Combined – CPS Energy – Large Load Additions Project (25RPG020) and South Texas Electric Cooperative (STEC) – Medina County Load Project (25RPG046) – ERCOT Independent Review (EIR) Status Update

Regional Planning Group (RPG) Meeting
April 13, 2026

Option 1 – CPS Energy Proposed Option

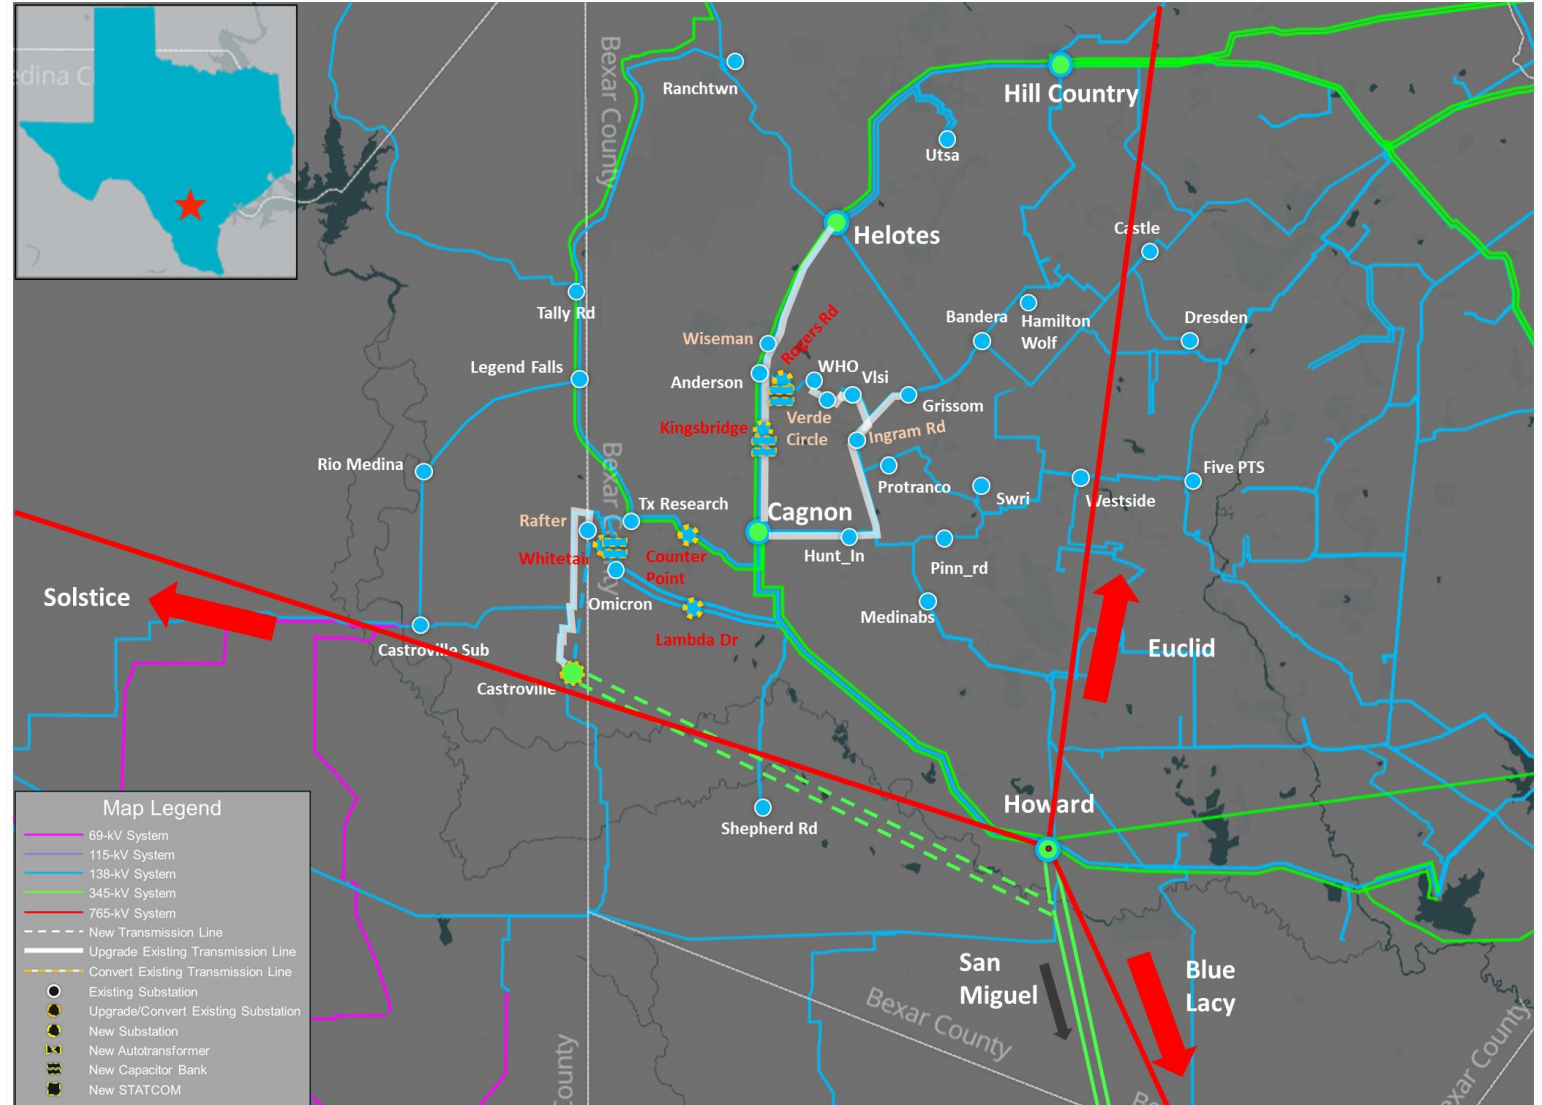
Option	N-0		N-1		G-1+N-1*		X-1+N-1*		Unsolved Power Flow
	Thermal Violations	Voltage Violations	Thermal Violations	Voltage Violations	Thermal Violations	Voltage Violations	Thermal Violations	Voltage Violations	
1	3	1	17	20	2	1	3	2	2
2	None	None	7	None	None	None	3	None	None

Key Takeaway: Both Option 1 and Option 2 observed reliability violations, ERCOT will continue to evaluate other alternative Options to solve the reliability violations
